REZONING CASE NUMBER: 2018-077

HAMILTON PARK
REZONING PLAN
SOUTH-WEST CORNER OF THE INTERSECTION OF
STEELE CREEK ROAD AND HAMILTON ROAD
CHARLOTTE, NORTH CAROLINA 28273

PROJECT NO.	RTD-18000
FILENAME	RTD-18000-RZ1
CHECKED BY:	RMR
DRAWN BY:	JDL
SCALE:	1"=40'
DATE:	06-05-2018
SHEET NO.	RZ-1

**R2 DEVELOPMENT – HAMILTON PARK
REZONING PETITION 2018-077
RESPONSE LETTER – 09-26-2018**

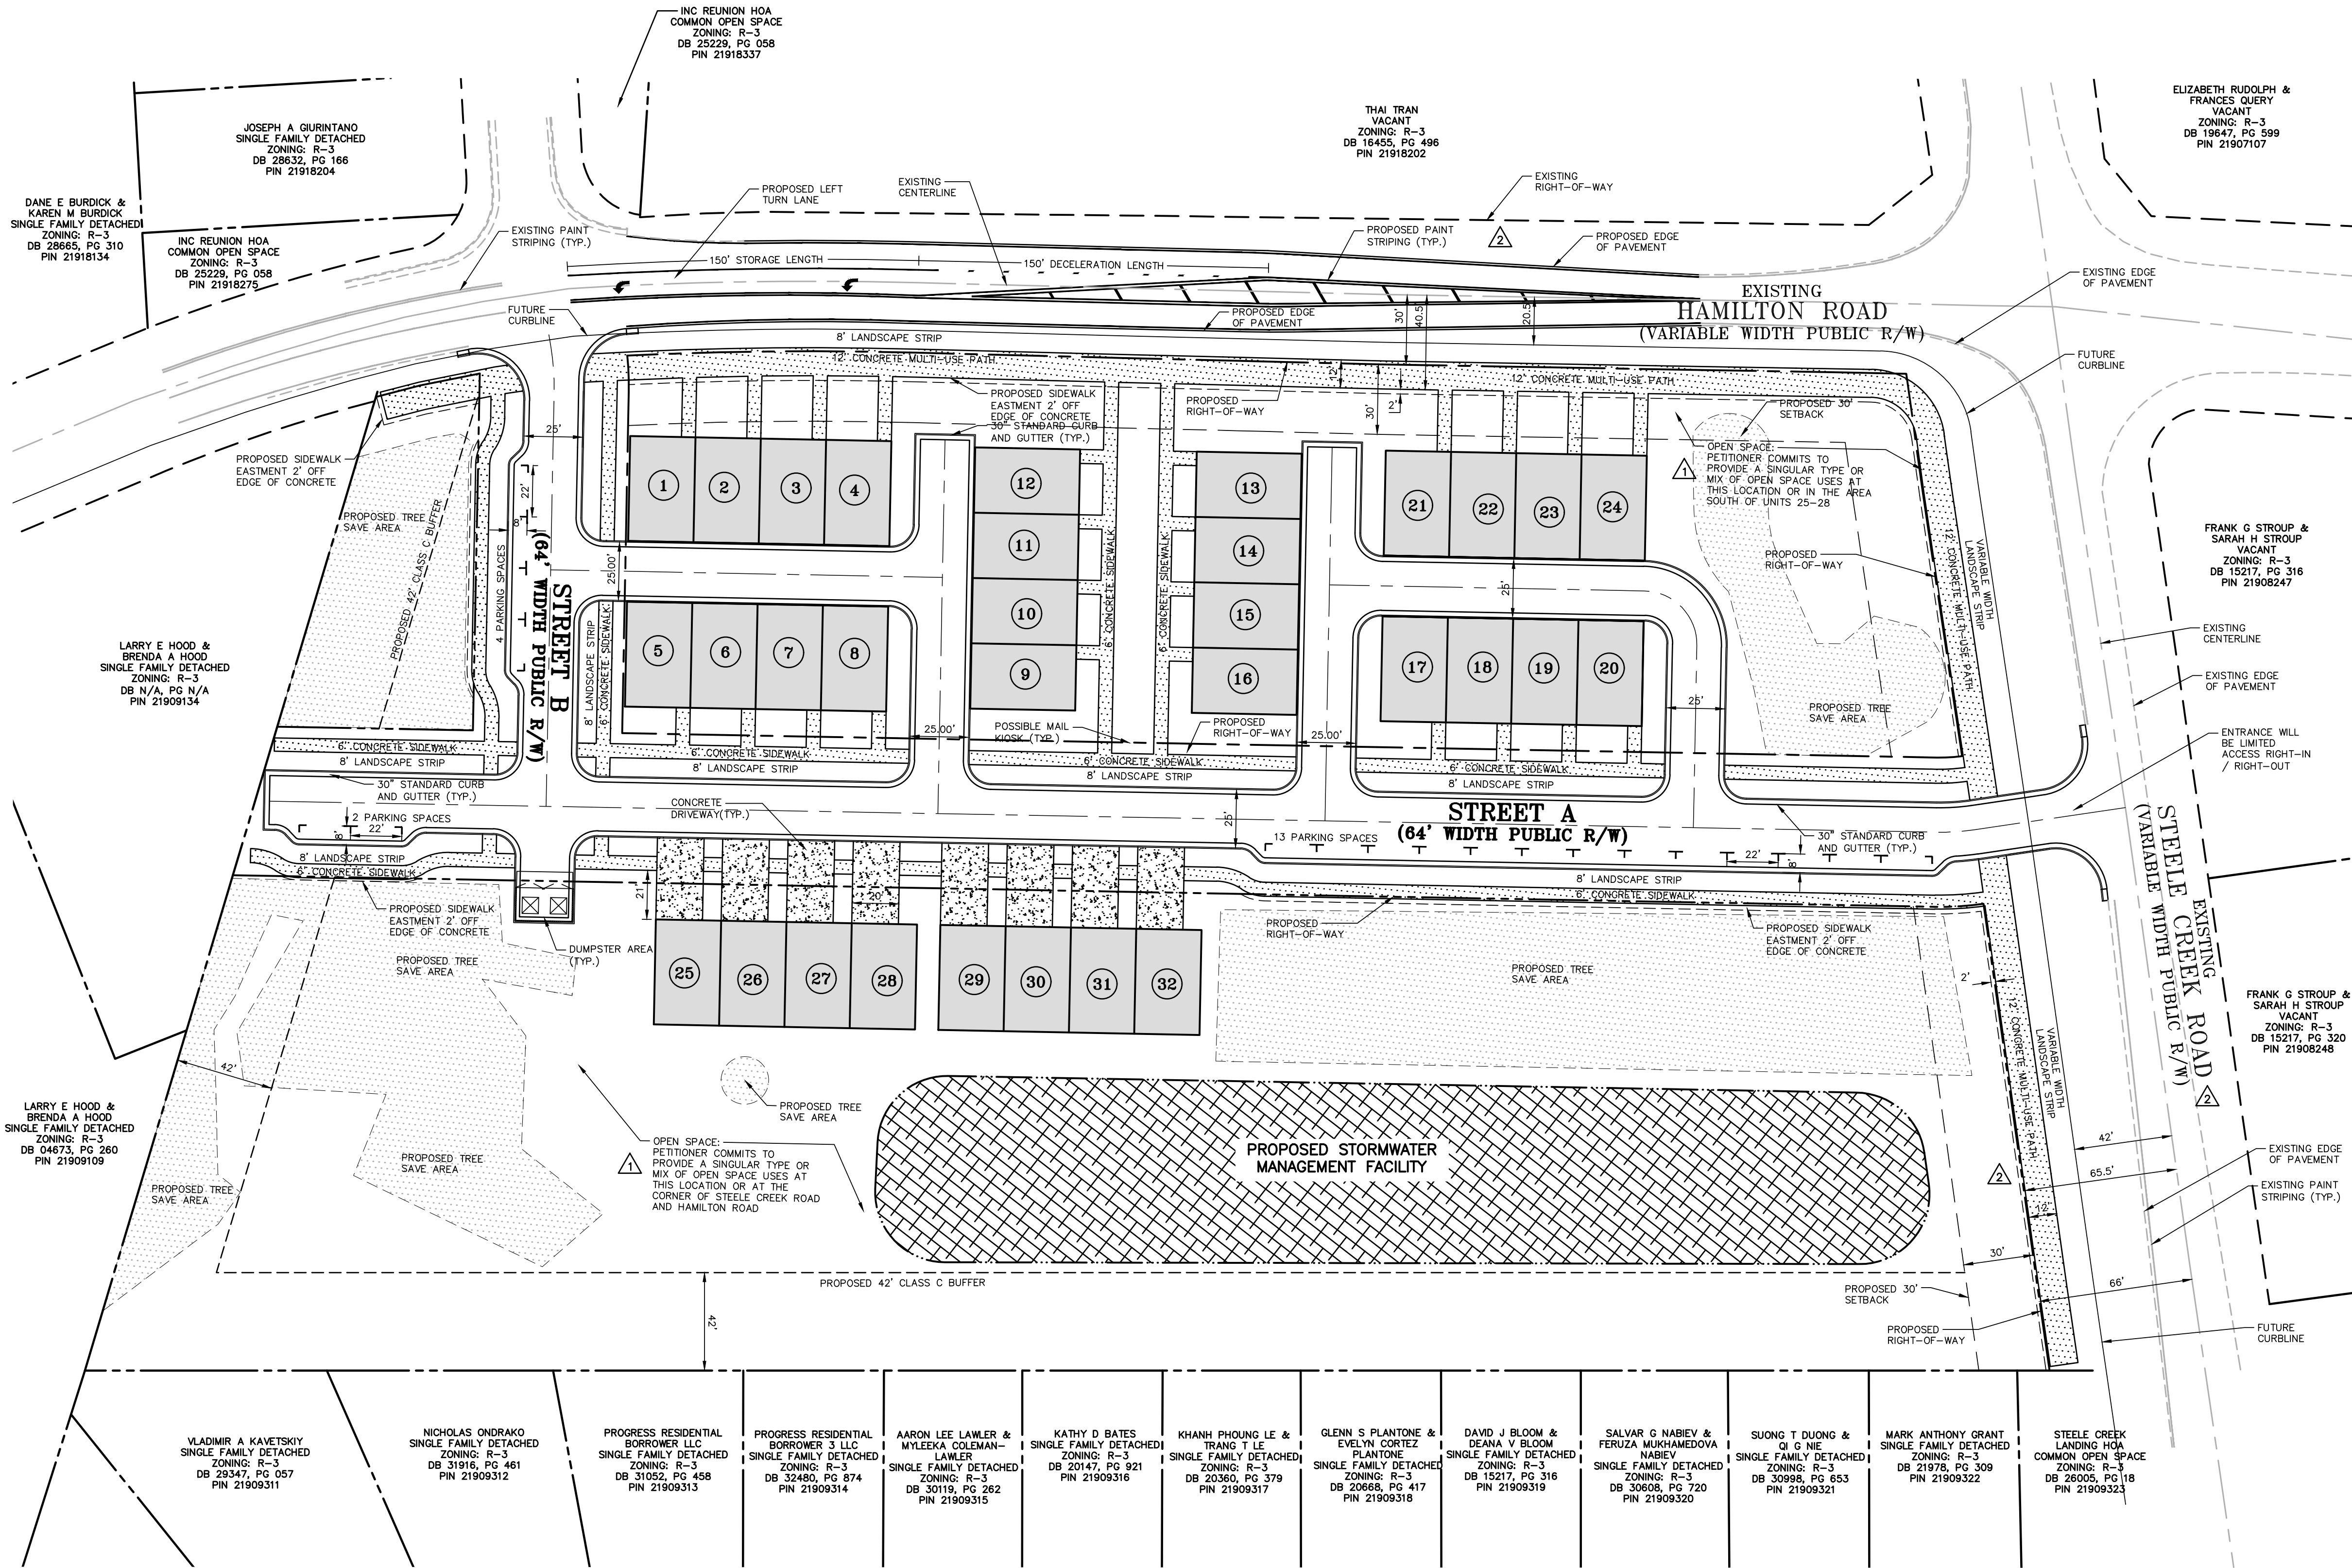
1. **Curbline** The proposed zoning district has a setback measured from back of the existing or proposed future curbline. The proposed cross section for the NCDOT widening project U-5766 has been updated. Based on the new cross section, the location of the future back-of-curb for:

- a. Steele Creek Road – 42 feet from centerline of the road (reduced from 53 feet)
- b. Hamilton Road – 20.5 feet from centerline of the road (reduced from 28 feet)

2. Revise the site plan to show:

- i. The back of multi-use path on Steele Creek Road located 65.5 feet from centerline of the road.
- ii. The back of multi-use path on Hamilton located 40.5 feet from centerline of the of the road.

- i. The back of multi-use path on Steele Creek Road located 65.5 feet from centerline of the road.
 - ii. The back of multi-use path on Hamilton located 40.5 feet from centerline of the of the road.
3. The right-of-way is shown incorrectly in the update site plan. Furthermore, the updated cross-section for the NCDOT widening project U-5766 has changed the right-of way. The petitioner should revise the site plan and conditional notes to show the dedication of right-of-way, fee simple, of 66 feet from centerline of Steele Creek Road (reduced from 75 feet).

4. The petitioner should revise the site plan to show the correct existing right-of-way on Hamilton Rd of 60 feet wide total, 30 feet from centerline of the road.

Response: Revised curblines from the centerlines of the roads have been provided:

- a. Steele Creek Road – 42 feet from centerline of the road
- b. Hamilton Road – 20.5 feet from centerline of the road

Response: The site plan has been revised to show:

Response: The ROW for Steele Creek Road has been revised to reflect the above.

Response: The ROW for Hamilton Road has been revised to reflect the above.
